**OLYMPIA DESIGN REVIEW BOARD
RECOMMENDATION**

PROJECT NAME: Intercity Transit, Pattison Site Expansion Phase II

PROJECT No.: 19-1636

**CONCEPT DESIGN REVIEW
STAFF REPORT
June 27, 2019**

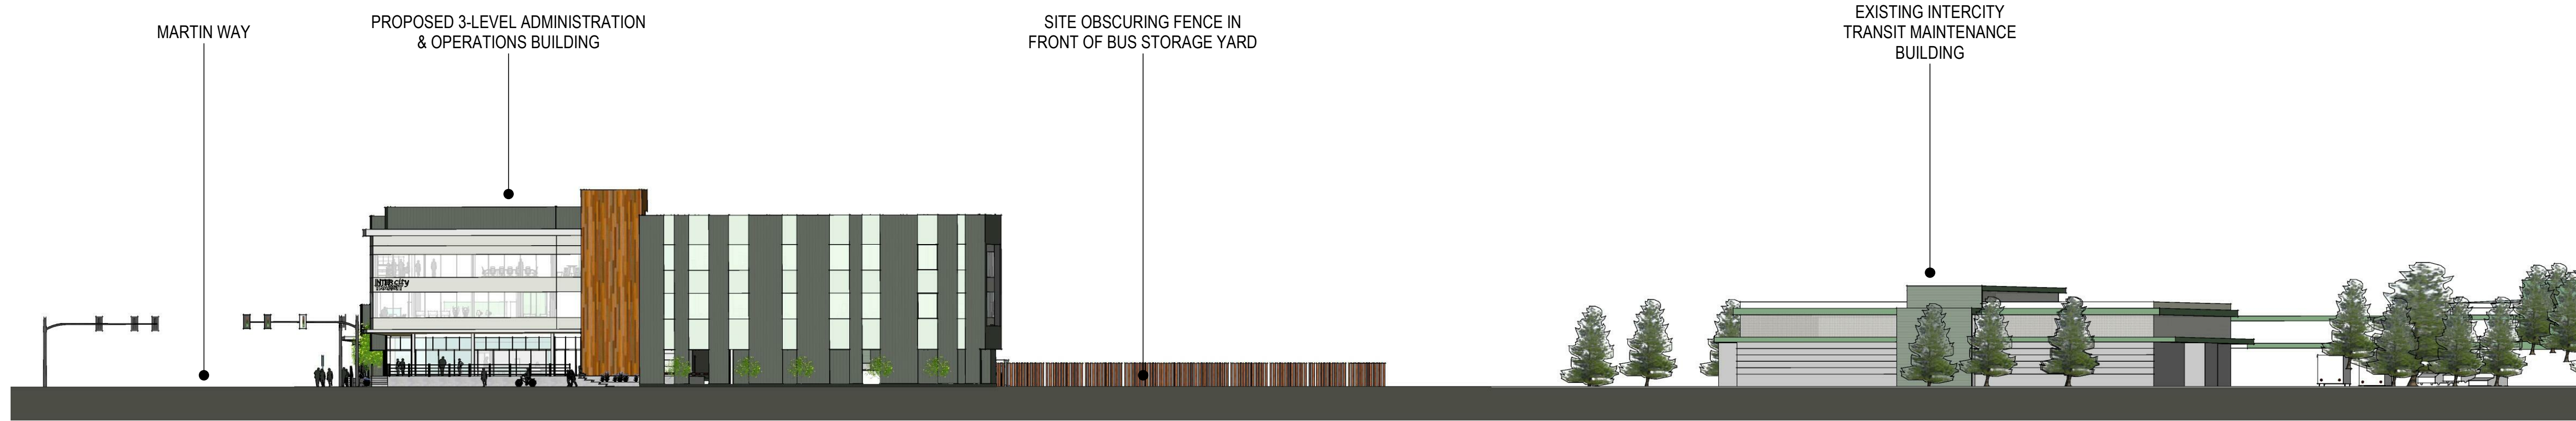
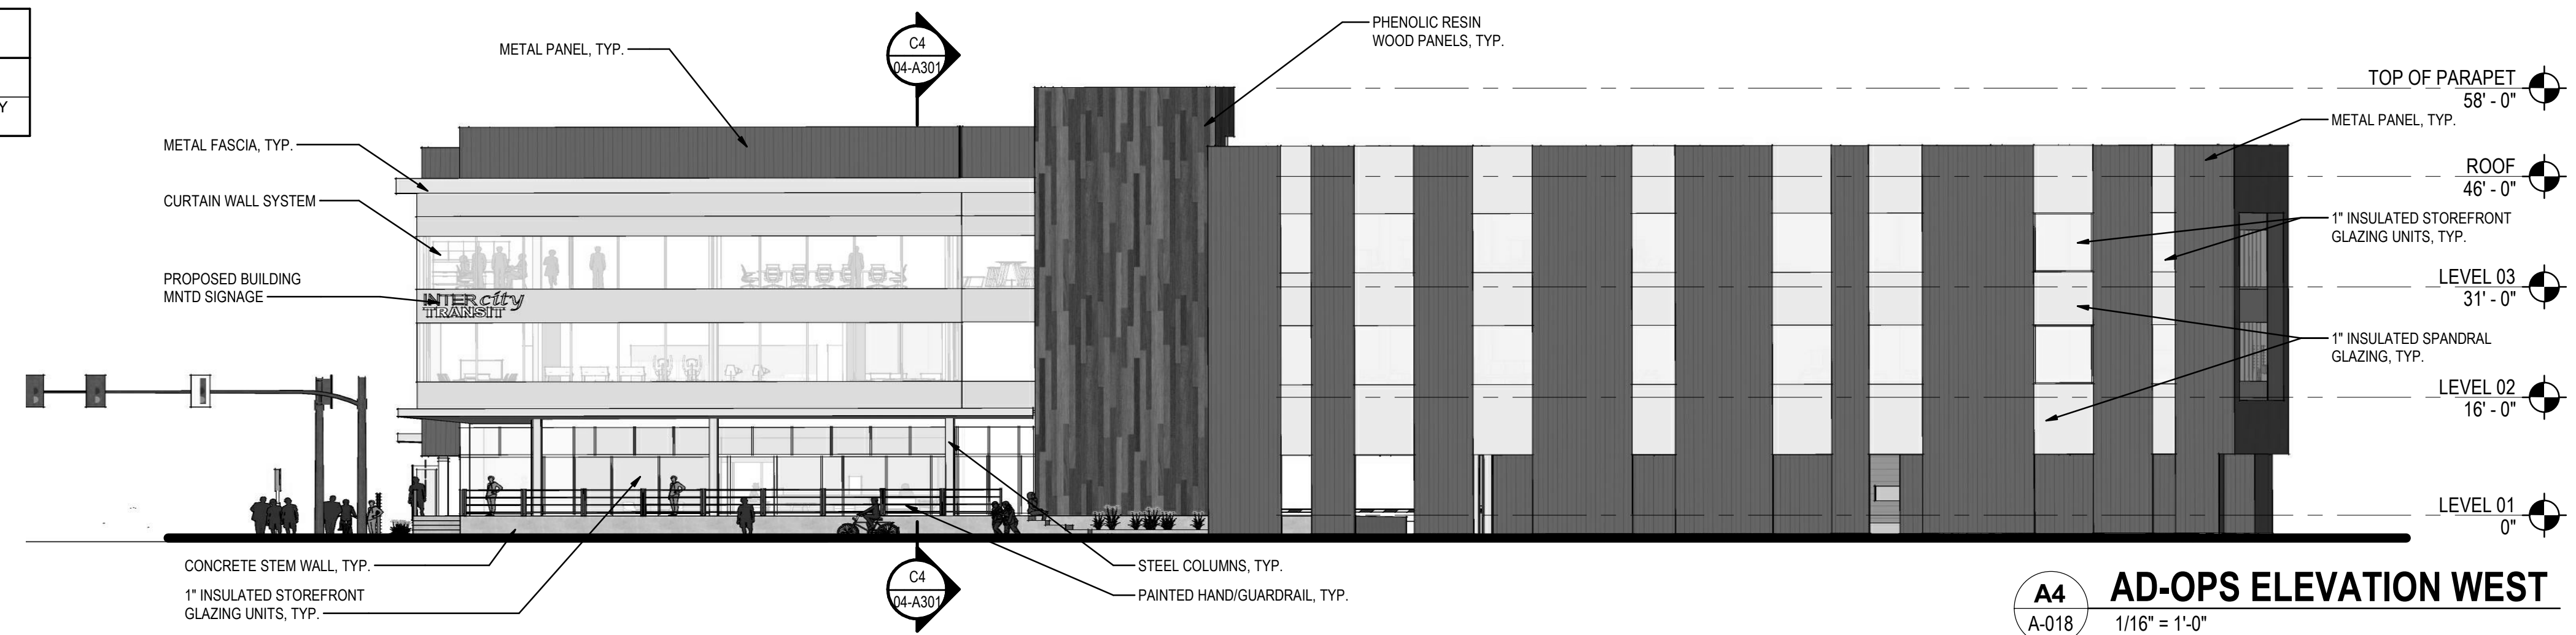
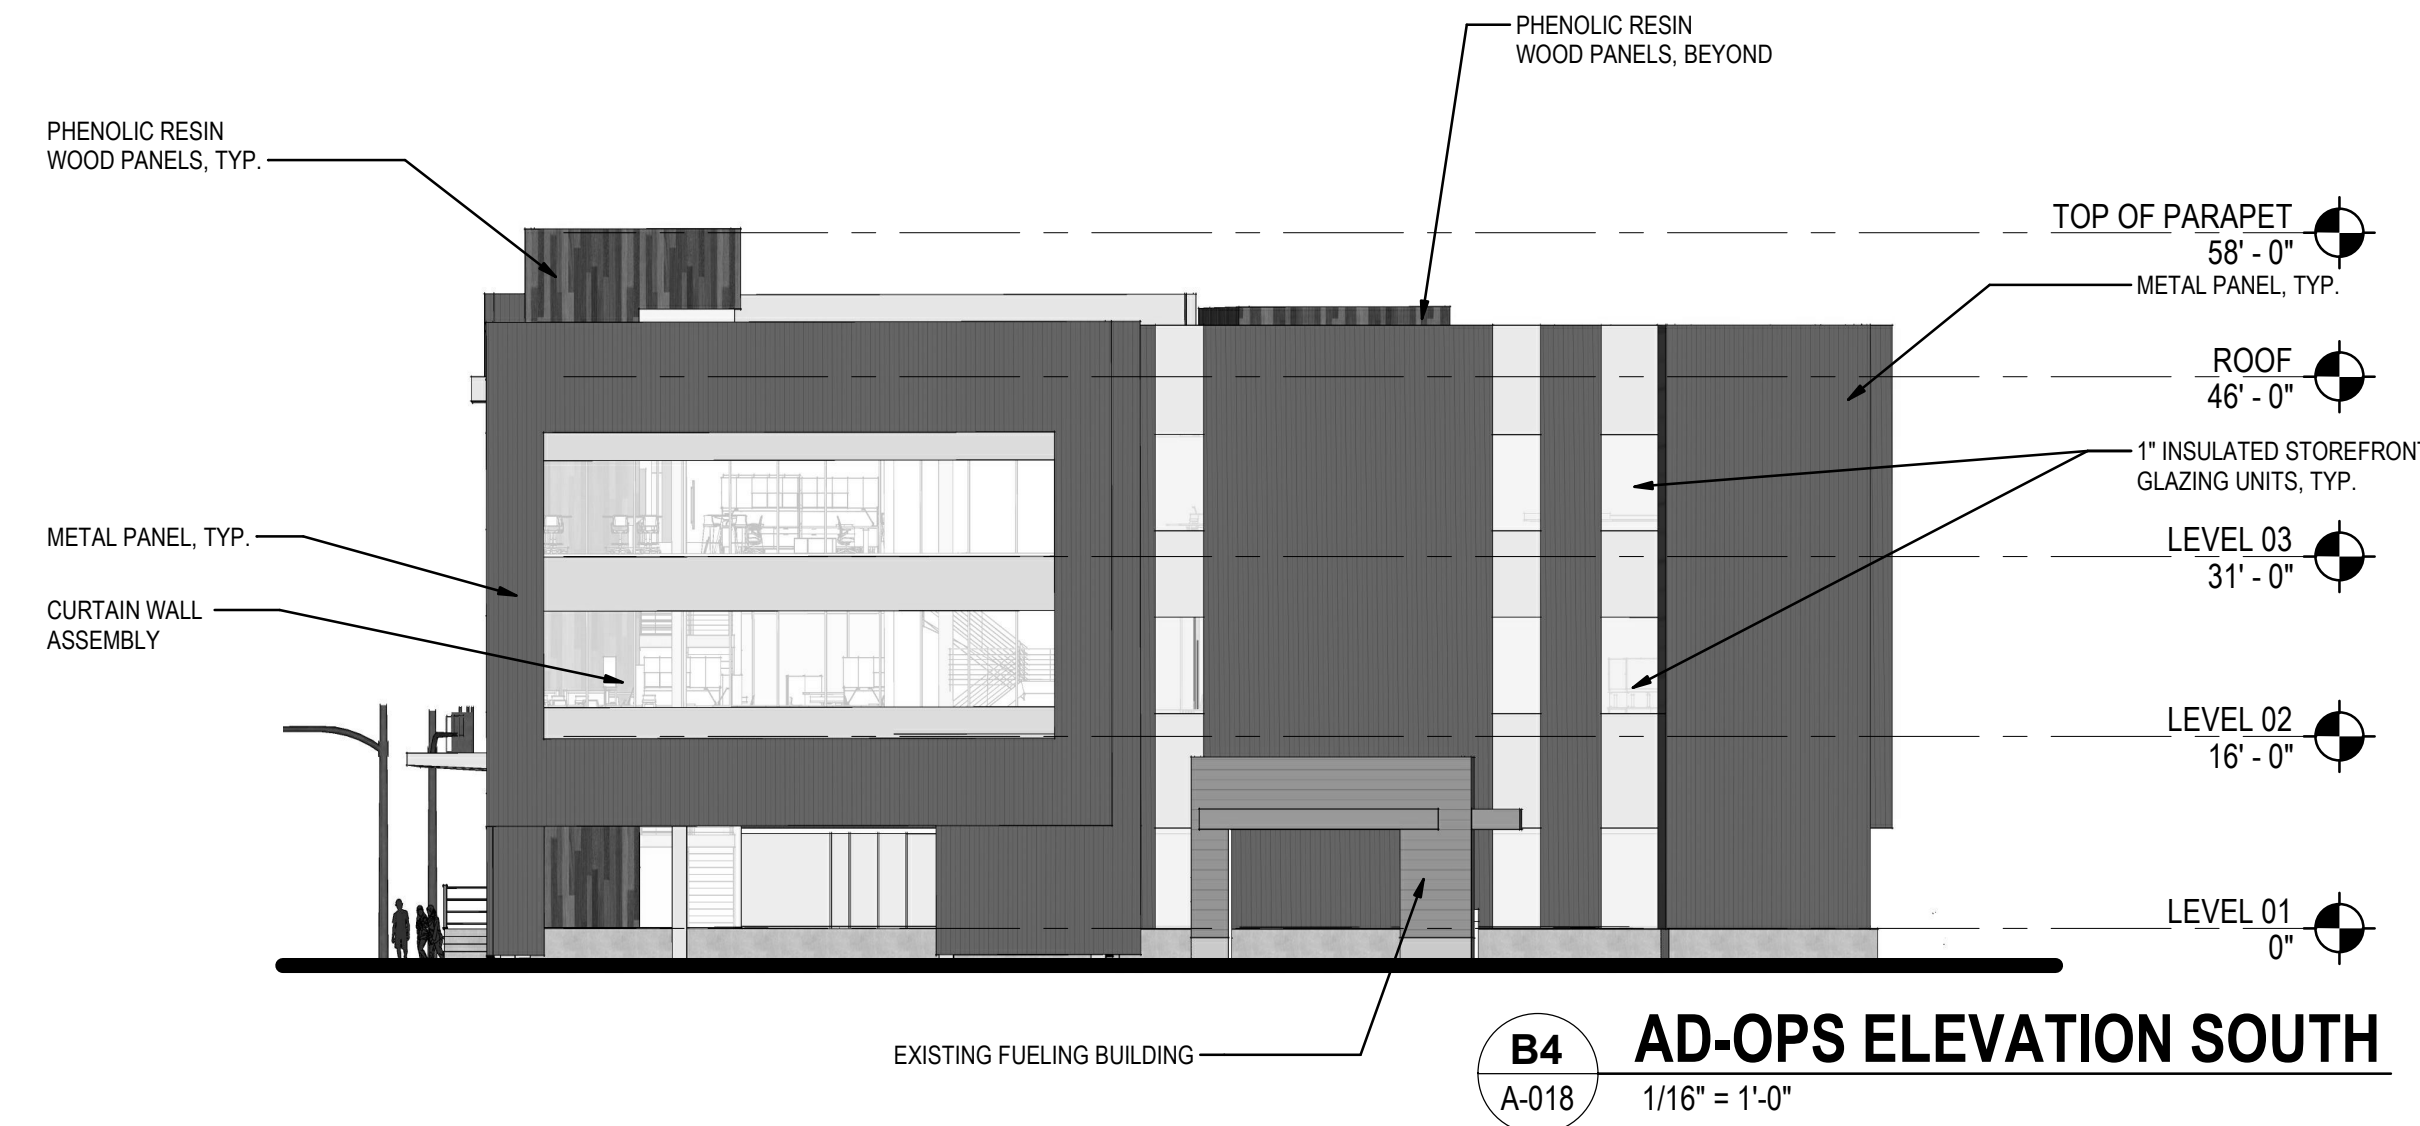
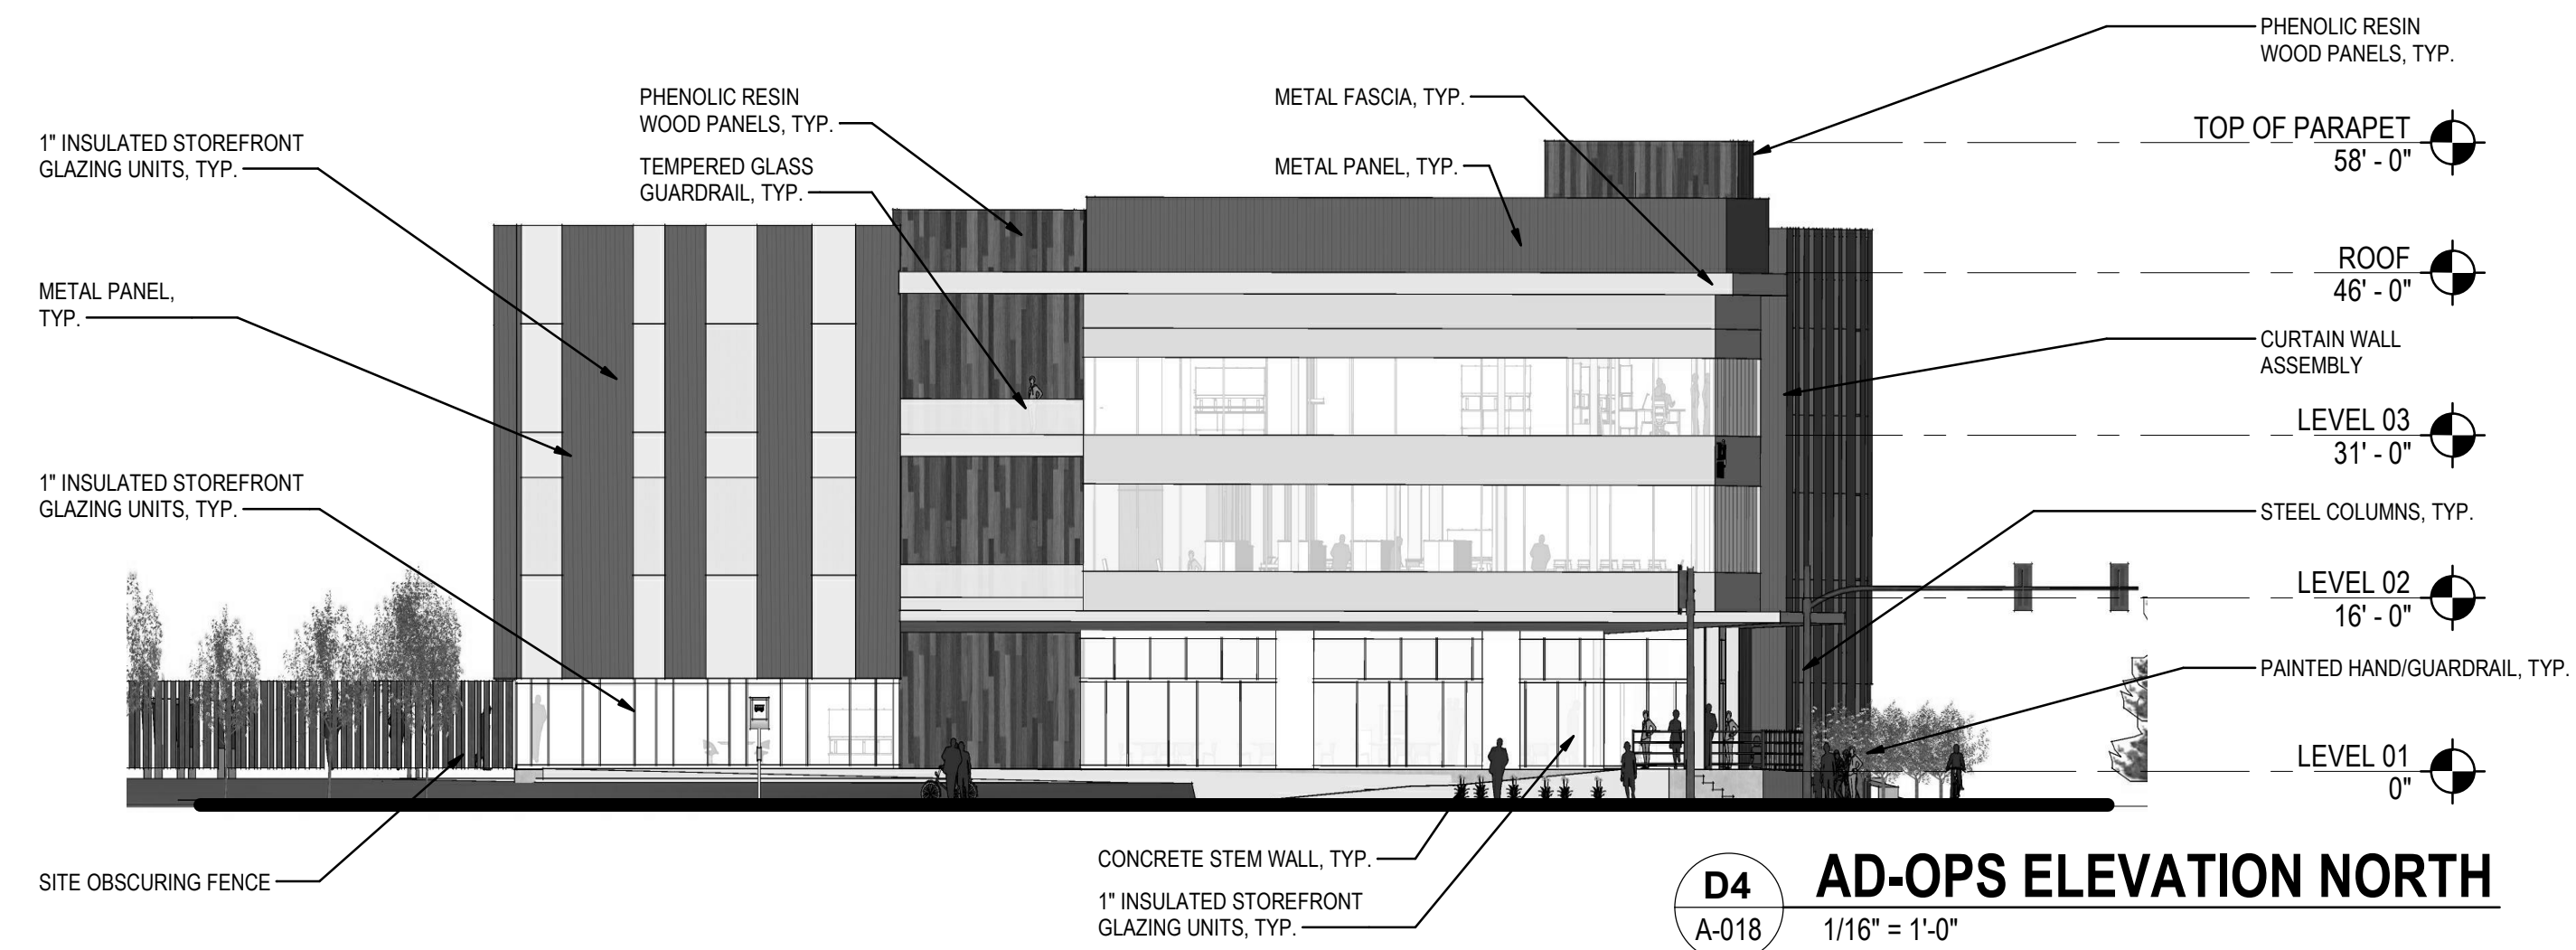
A minimum of 60 percent of the street façade between two and eight feet in height must be screened when placed on a street frontage. The parking proposed in the administration building is directly adjacent to Pattison Street and must comply with this standard. Plans do not show the requisite screening. The code establishes several ways in which to obtain compliance such as decorative metal grille work, artistic detailing, vertical trellises, and landscaping. The landscaping plan indicates several trees, shrubs and ground covers will be installed in the landscaping area between the sidewalk and the street, however it is not clear if this landscaping alone will adequately provide screening. Additionally, all surface parking facing a street must be screened with landscaping, berms or low walls. It is unclear if surface parking areas will be adequately screened.

The code requires for long expanses of blank walls or fences to be screened. The fencing along Martin Way between the buildings and the fencing behind the administrative structure separating the public and employee only area appear to be long expanses of fencing/walls. The elevations do not show screening, but the landscaping plan shows a series of trees and shrubs in these locations. It is likely that these plantings will adequately screen the long expanses of fencing, however in some areas it is somewhat unclear if plantings are proposed on the inside or outside of the fencing. For example, the landscaping plan shows a fenced employee area along Martin Way associated with the fuel, wash, and facilities building that includes vegetation on the inside, but not outside of the fence. This area is not easily identifiable from the elevation plans, but can be seen on the landscaping plan. Elevation plans that show landscaping would help show the effect the proposed landscaping has on the long expanses of fencing and other portions of the building. This is necessary to determine if the landscaping adequately screens these long expanses of fences.

The code requires all walls visible to pedestrians that are over 30 ft. in length to be modulated and building elements to be articulated. The façade along the administrative building comply, but there are some areas along the façade of the fuel, wash, and facilities building that are 45 ft. in length without modulation. Plans should be revised to comply.

Staff Response for Conceptual Review: At grade vehicular parking is proposed along Pattison Street. The elevation plan does not show the type of screening, artwork, or other features intended to meet this requirement. The landscaping plan shows plantings and street trees along this frontage that will provide some screening.

Staff Response for Conceptual Review: The code asks for long expanses of blank walls or fences to be screened. The fencing along Martin Way between the buildings and the fencing behind the administrative structure separating the public and employee only area appear to be long expanses of fencing/walls. The elevations do not show screening, but the landscaping plan shows a series of trees and shrubs in these locations. It is likely that these plantings will adequately screen the long expanses of fencing, however in some areas it is somewhat unclear if plantings are proposed on the inside or outside of the fencing. For example, the landscaping plan shows a fenced employee area in along Martin Way

associated with the fuel, wash, and facilities building that includes vegetation on the inside, but not outside of the fence. This area is not easily identifiable from the elevation plans, but can be seen on the landscaping plan. Elevation plans that show landscaping would help show the effect the proposed landscaping has on the long expanses of fencing and other portions of the building. This is necessary to determine if the landscaping adequately screens these long expanses of fences.

Staff Response for Conceptual Review: There is one section of the facilities building that includes a wall of approximately 46 ft. in length without modulation or other building elements and the fencing between the two buildings spans 75 ft. without modulation. The 30 ft. length is a requirement, therefore plans will need to be revised to comply.

Staff Response for Conceptual Review: The visitor parking is located under the building at ground level along the frontage of Pattison Street. It has been strategically located to tuck in behind the building frontage and prominent intersection of Pattison Street and Martin Way. It is unclear if the street level surface parking will be adequately screened. The landscaping plan shows several trees and shrubs directly in between the sidewalk and the parking lot, but metal work or other features that would allow climbing plants has not been identified.

Proposed Condition of Approval: The applicant shall revise the elevation plans to show proposed screening devices and plantings to ensure 60 percent coverage between two and eight feet in height along the wall.

Condition of approval: Show landscaping and other site features that are intended to be greater than 30 in. above grade in the elevation plans with Detail Design Review.

Condition of Approval: Revise plans to ensure walls are modulated at intervals of no less than 30 ft. where visible from pedestrians.

Condition of Approval: Show the proposed features that will provide texture and screening to the surface level parking. Use artwork, metal grille work or similar detailing that provides texture and covers the parking structure openings.

Condition of approval: Show landscaping and other site features that are intended to be greater than 30 in. above grade in the elevation plans with Detail Design Review.

Condition of Approval: Revise plans to ensure walls are modulated at intervals of no less than 30 ft. where visible from pedestrians.

Condition of Approval: Show how screening of the surface level parking below the building on the Pattison Street frontage is being provided.
